ALTERATION OF A LOCAL HISTORIC DISTRICT (LHD) PROPERTY
STAFF REPORT

Site: 57 Columbus Avenue

Case: HP24-000032

HPC Meeting Date: June 04, 2024

Above: Proposed right elevation

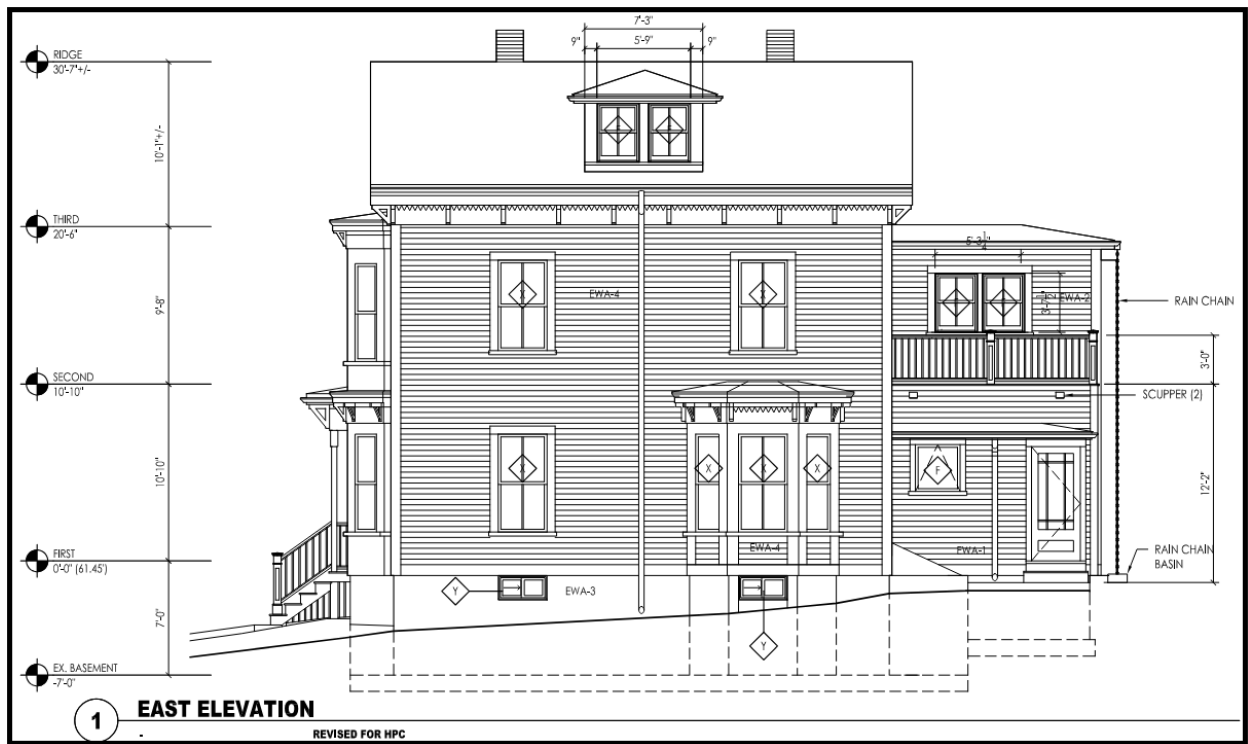
It is important to note that all portions of the structure are visible from a right-of-way given that Prospect Park is located behind the property. Parks are considered a public right-of-way. The updated proposal for railing is in line with Staff’s suggestion to use a more historically appropriate railing design. Preservation Staff has included conditions in Section IV ‘Recommended Conditions’ below regarding the use of wood clapboard.

3. The railings on the mudroom addition deck will be wood and match in style, to the front portico railings.
4. The front façade portico shall utilize wood steps, railings, landings, steps, and columns.

Above: Photo of existing portico

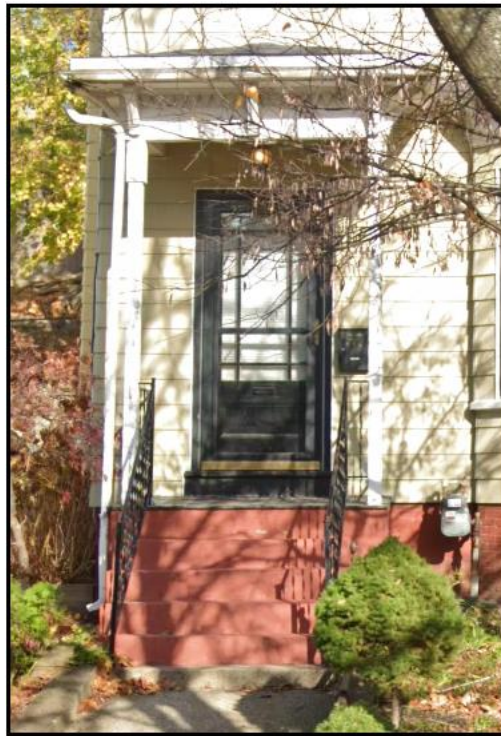
The existing portico on the front facade has concrete masonry steps leading to a timber frame landing. The existing steps and landing of the portico are not original, although the roof and supporting columns appear to be. When the Applicant first came before the HPC they proposed to rebuild the base of the portico with brick and granite for the stair treads.

After discussion with the HPC the Applicant has updated their proposal to be that the portico's stairs, rails, and landing be re-built in wood.

Above: Rendering of proposed portico

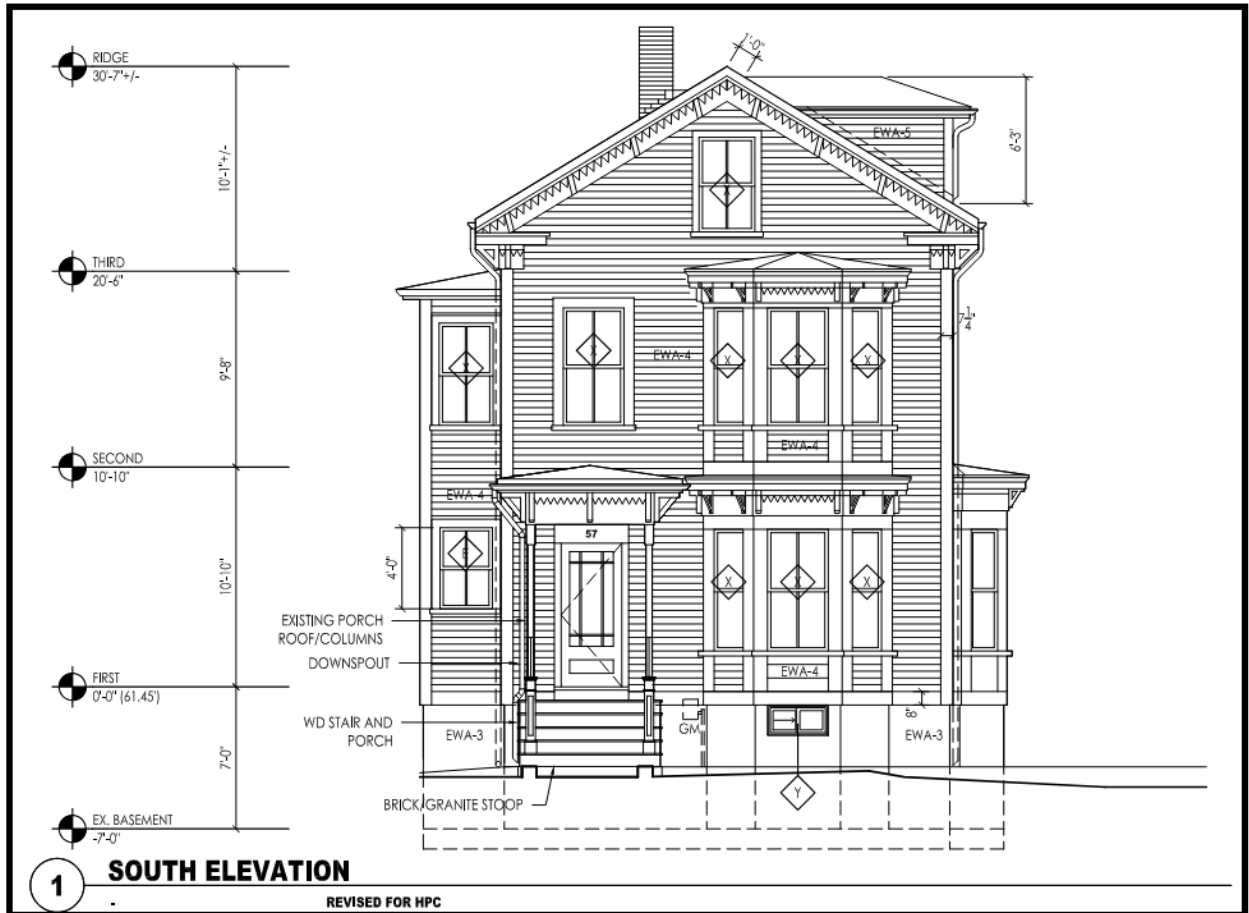
Given the time of construction and style, the portico would have been constructed from wood with a brick foundation. The Applicant’s proposal to use wood with turned style-wood to rebuild the portico is compliant with the Historic Design Guidelines. Preservation Staff has included conditions in Section IV ‘Recommended Conditions’ below regarding the portico.
